## CONNECTICUT SITING COUNCIL

RE: **EM-AT&T-014-190211** – AT&T Mobility, LLC notice of intent to modify an existing telecommunications facility located at 4 Beaver Road, Branford, Connecticut.

On February 18, 2019, the Council received a MA prepared by Infinigy and dated January 31, 2019 and a CD prepared by Infinigy and last revised February 13, 2019. Staff has reviewed the response and observed the following deficiencies:

Staff has reviewed this exempt modification request for completeness and has identified a deficiency in the request. The construction drawing Sheet C3 and C4 prepared by Infinigy, last revised on January 23, 2019, includes a mount note referencing a post-modification mount analysis report prepared by Infinigy and dated January 21, 2019. No post-modification mount analysis report is included with the request for exempt modification and the Structural Analysis Report provided with the request does not account for the proposed mount modifications as shown on drawing S2.

Drawing Number  
**S2**

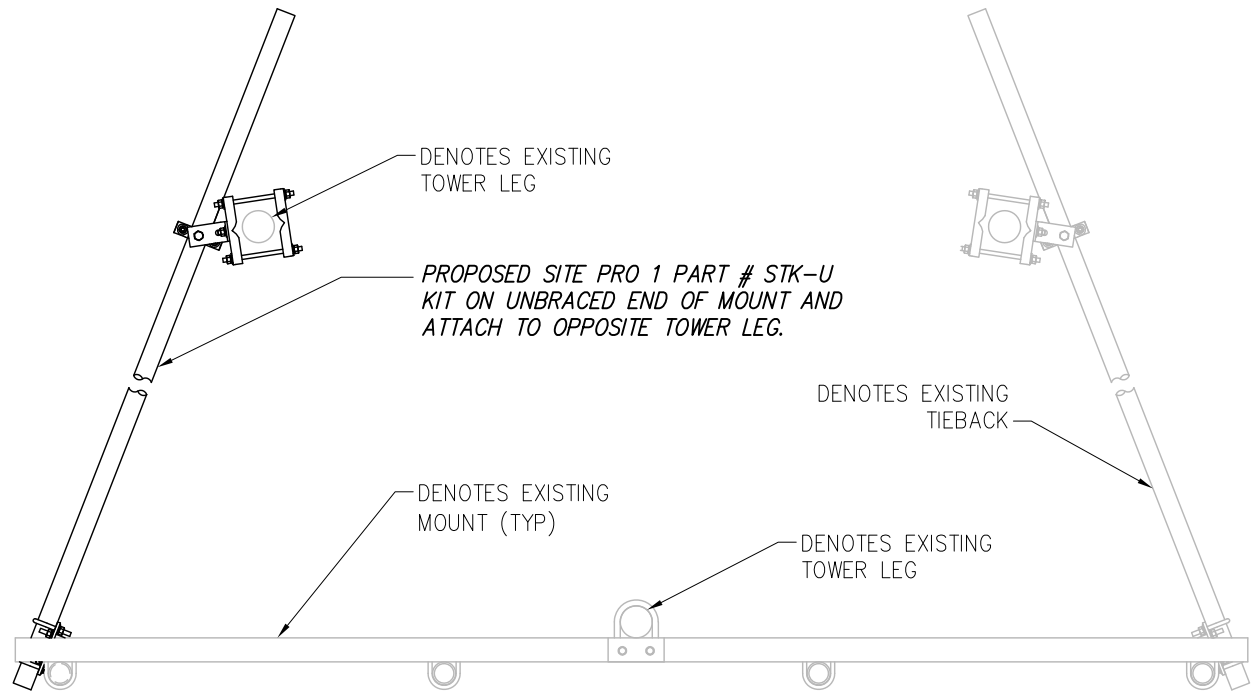
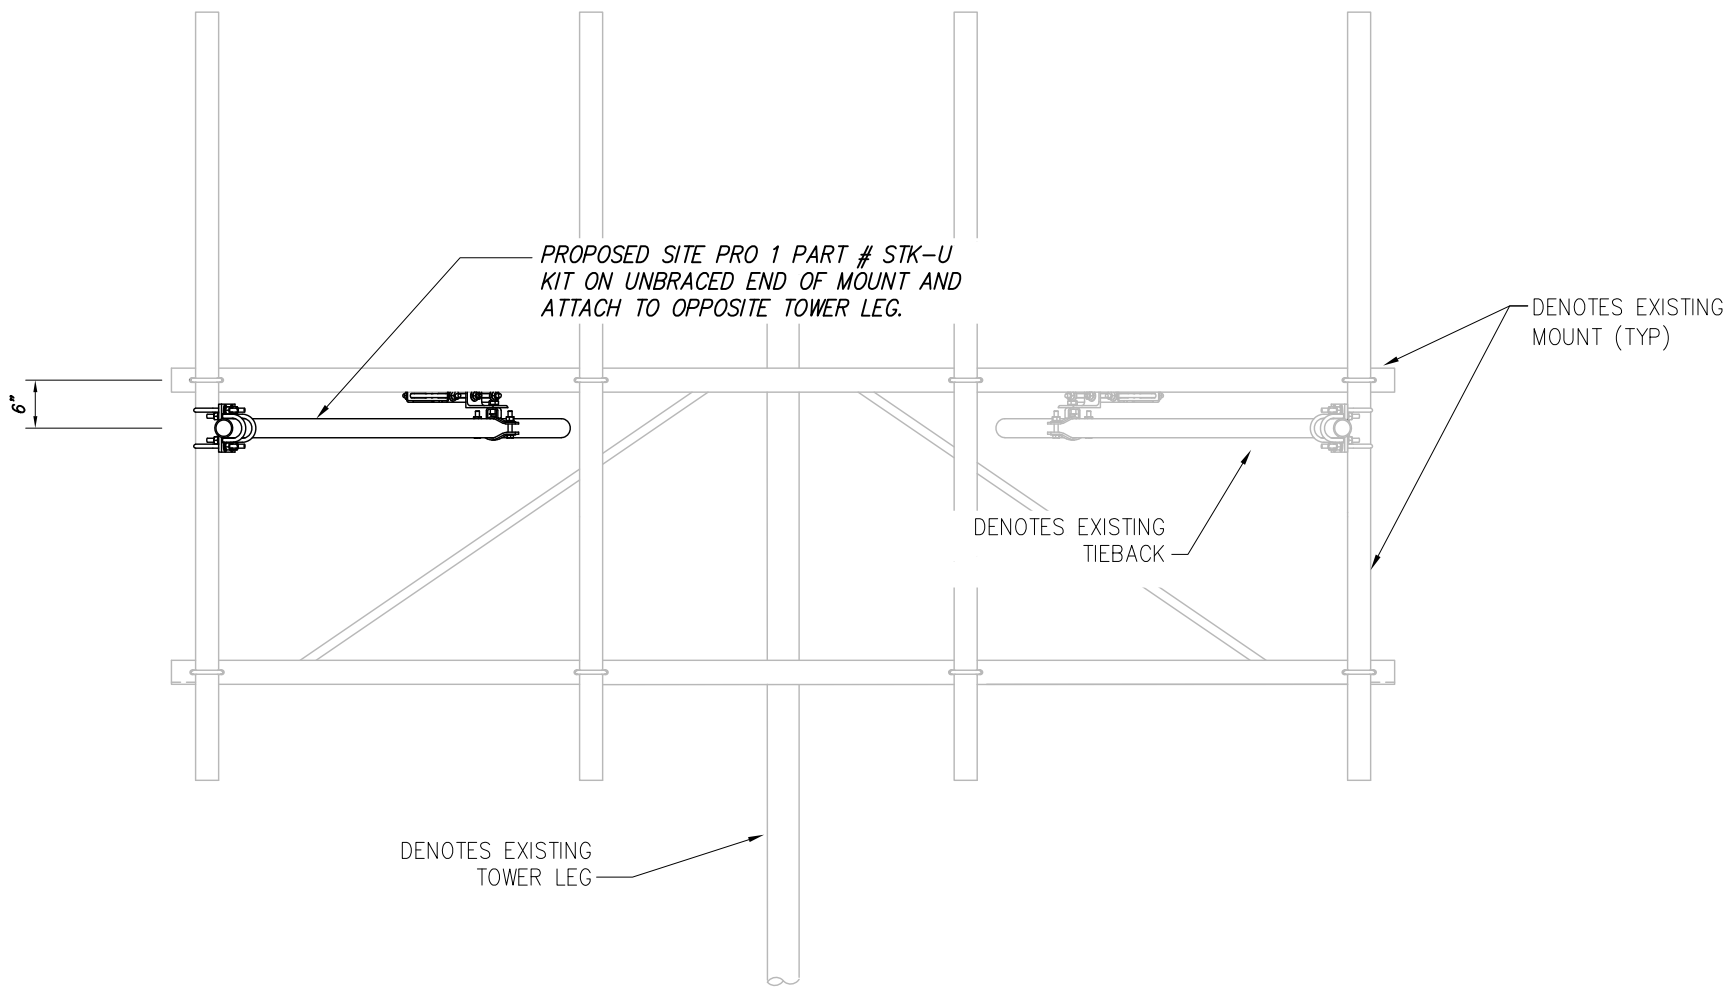
- a. The Structural Analysis Report dated January 7, 2018 does not account for the mount modifications proposed in the MA dated January 31, 2019. The SA must be rerun with the proposed mount modifications.
- b. The revised CD references a January 21, 2019 MA; however, the MA submitted is dated January 31, 2019.

Therefore, the exempt modification request remains incomplete at this time. The Council recommends that Smartlink, LLC provide a Structural Analysis Report that accounts for the mount modifications proposed in the MA and a CD that references the correct date of the MA, on or before March 25, 2019. If additional time is needed to gather the requested information, please submit a written request for an extension of time prior to March 25, 2019.

Therefore, the exempt modification request is incomplete at this time. The Council recommends that Smartlink provide a mount analysis for the proposed equipment that is stamped and signed by a professional engineer duly licensed in the State of Connecticut and an updated Structural Analysis Report accounting for any required antenna mount modifications on or before March 18, 2019. If additional time is needed to gather the requested information, please submit a written request for an extension of time prior to March 18, 2019.
